Northern Regional Power Committee

Subject: Agenda for 38th Protection Sub-Committee Meeting.

Agenda for
38th Meeting of Protection Sub-committee of
Northern Regional Power Committee

DR of 400/220 kV Bhadla (end) ICT-3

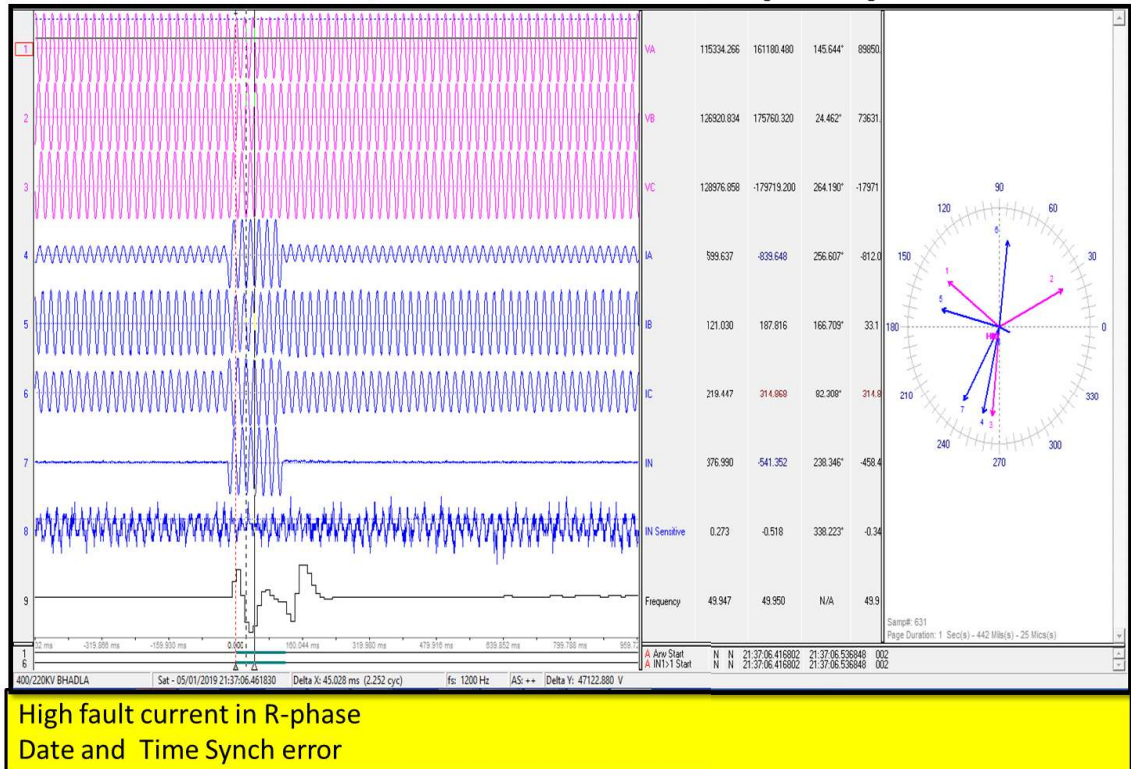
High fault current in R-phase
Date and Time Synch error

DR of Bus Sectionaliser at Bhadla (Raj)

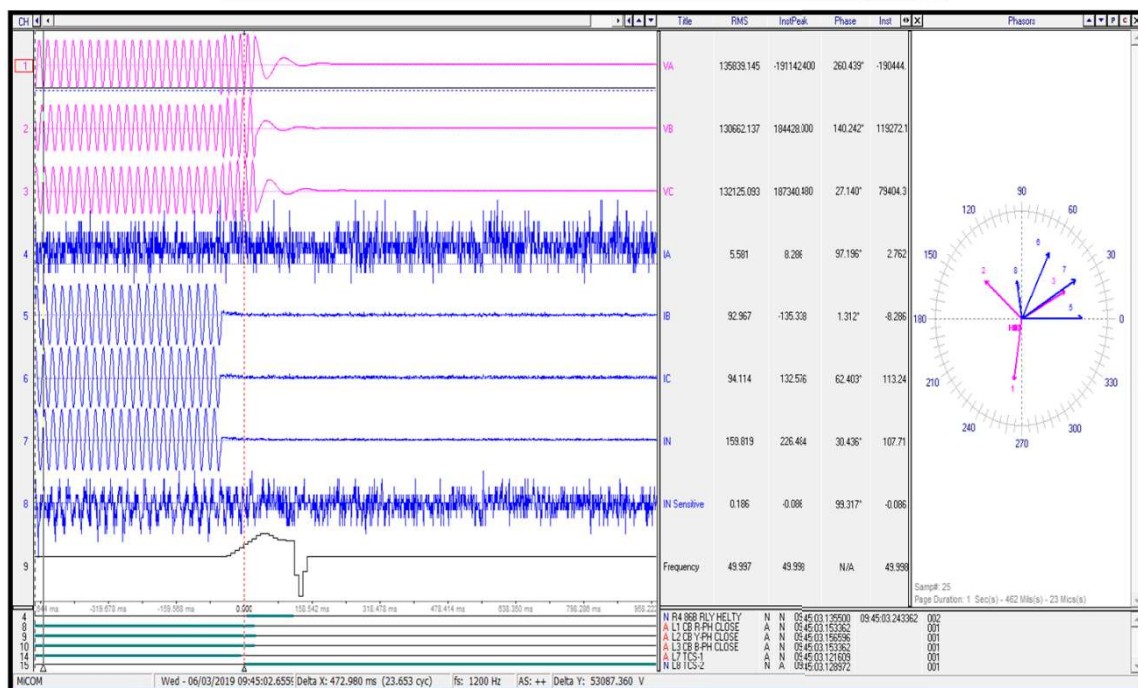
DR of different time or time sync error?

DR of Bus Sectionaliser at Bhadla (Raj)

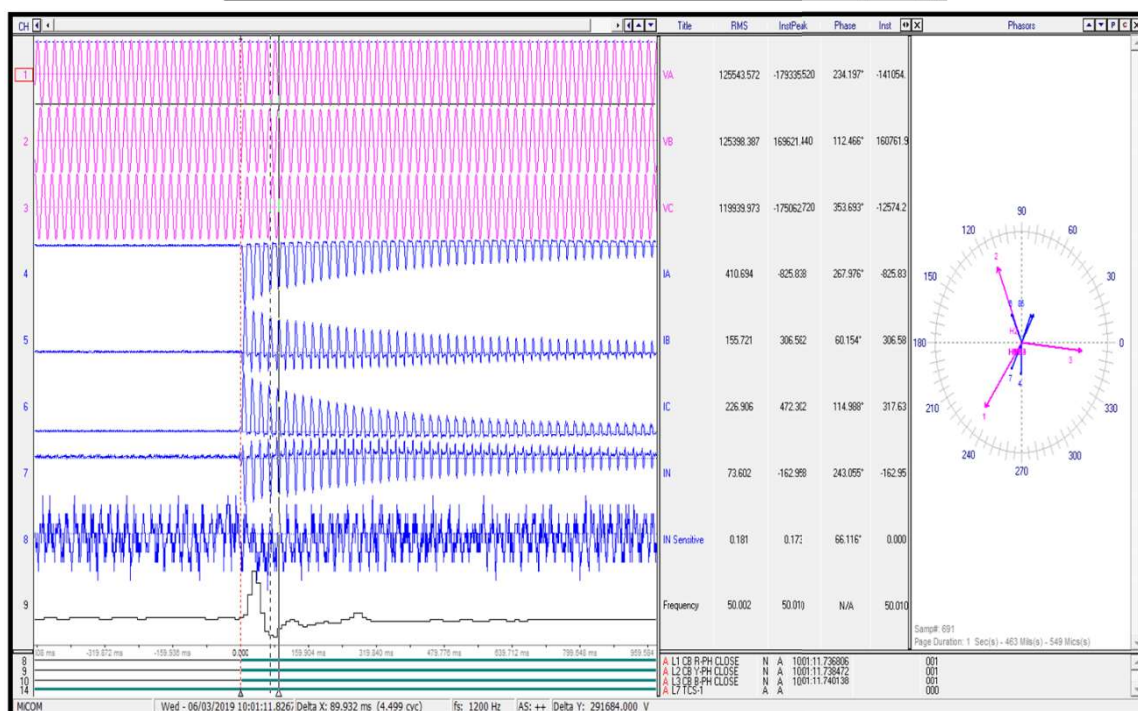
- DR of different time or time synchrony error?

1. Mal-operation of high impedance bus bar protection at 400 kV Jhakri HEP needs to be looked into.

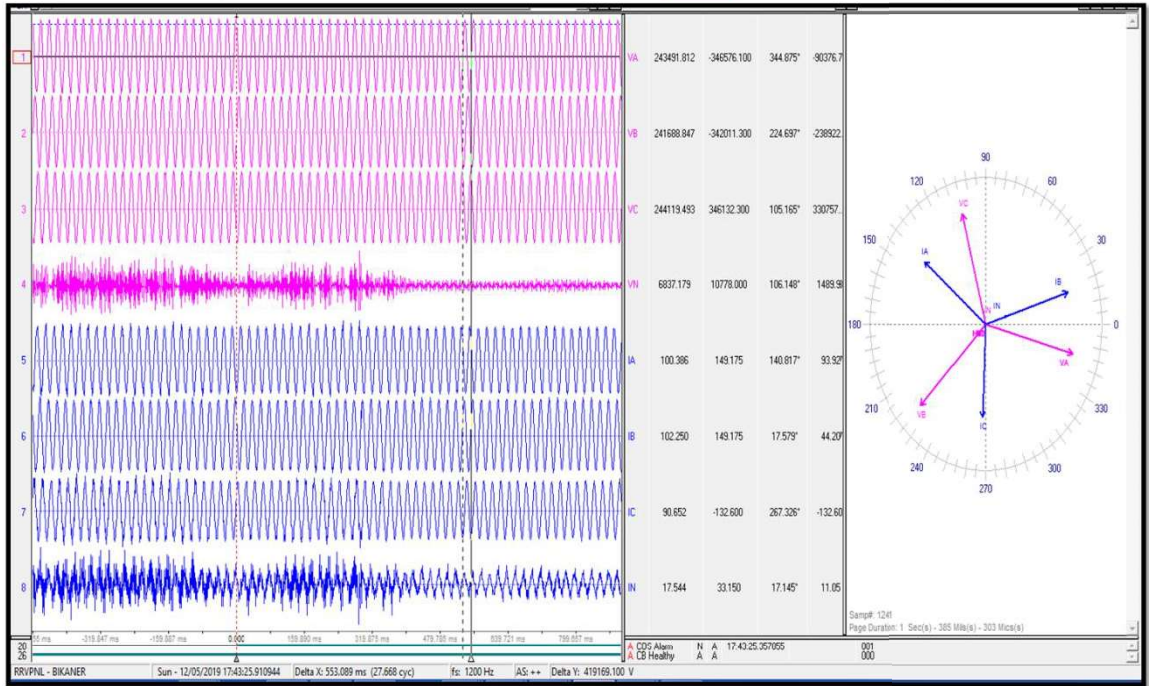
Reason of the tripping didn't clear from DR. Why master trip operated?

DR of 400 kV Bikaner (end)-Bhadla ckt-1

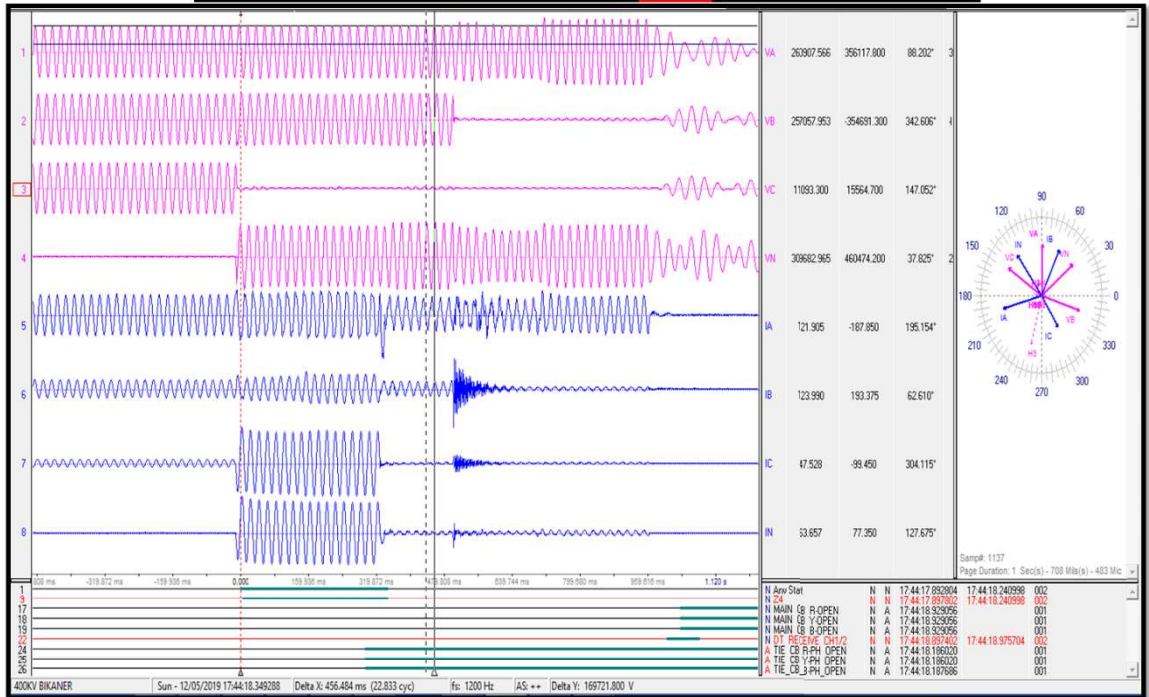
Reason of the tripping didn't clear from DR. Why master trip operated?

DR of 400/220 kV 315 MVA ICT-2 at Bawana (end)

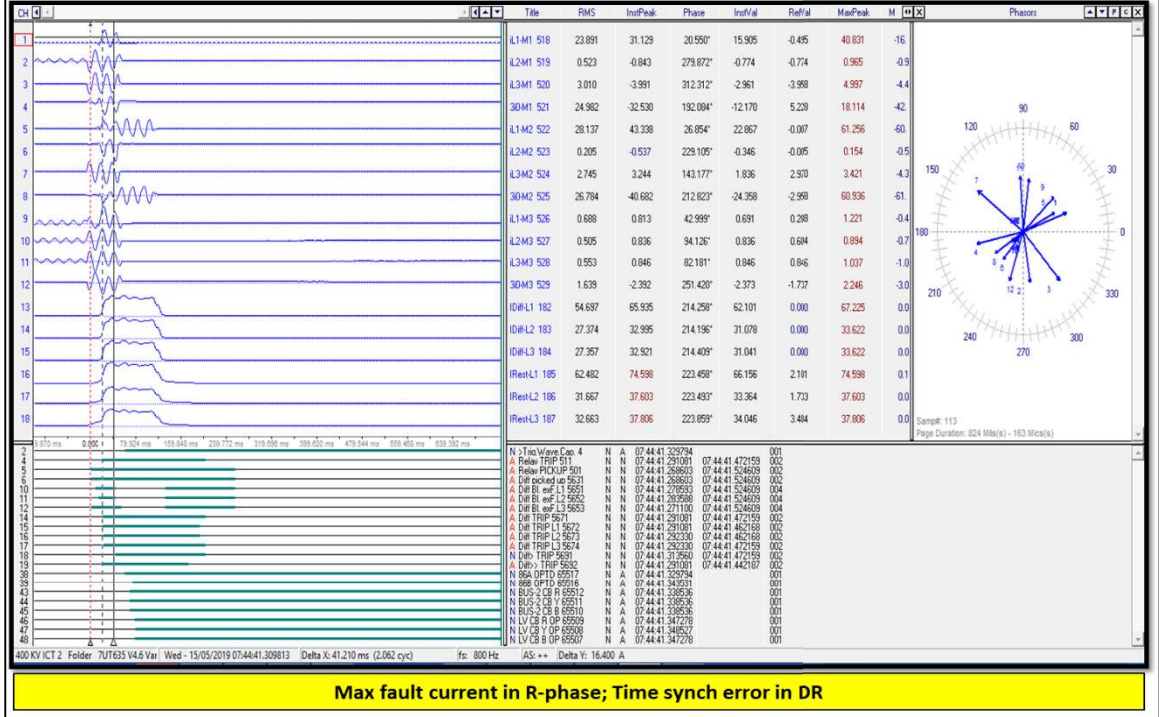
Fault sensed in reverse zone than in forward zone. Time synchron error in DR

DR of 400/220 kV 315 MVA ICT-3 at Bawana (end)

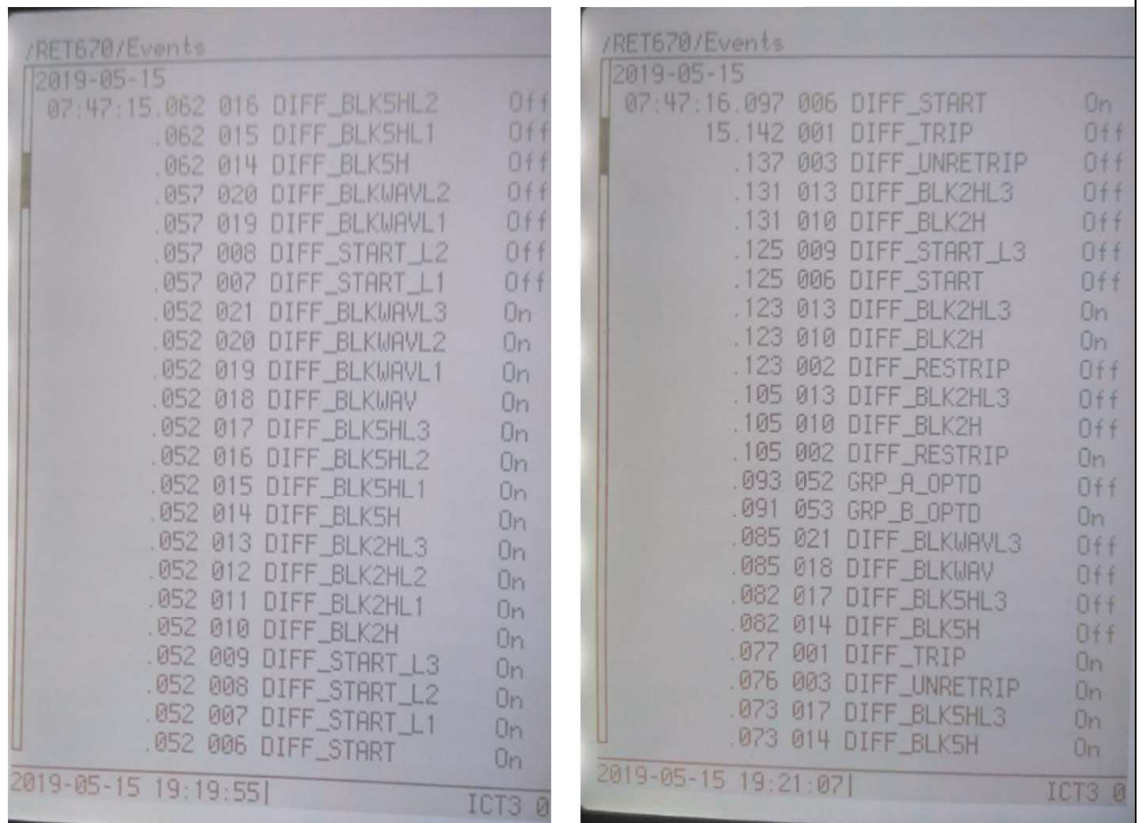
Max fault current in B-phase. Differential protection operated. Time synchron error in DR.
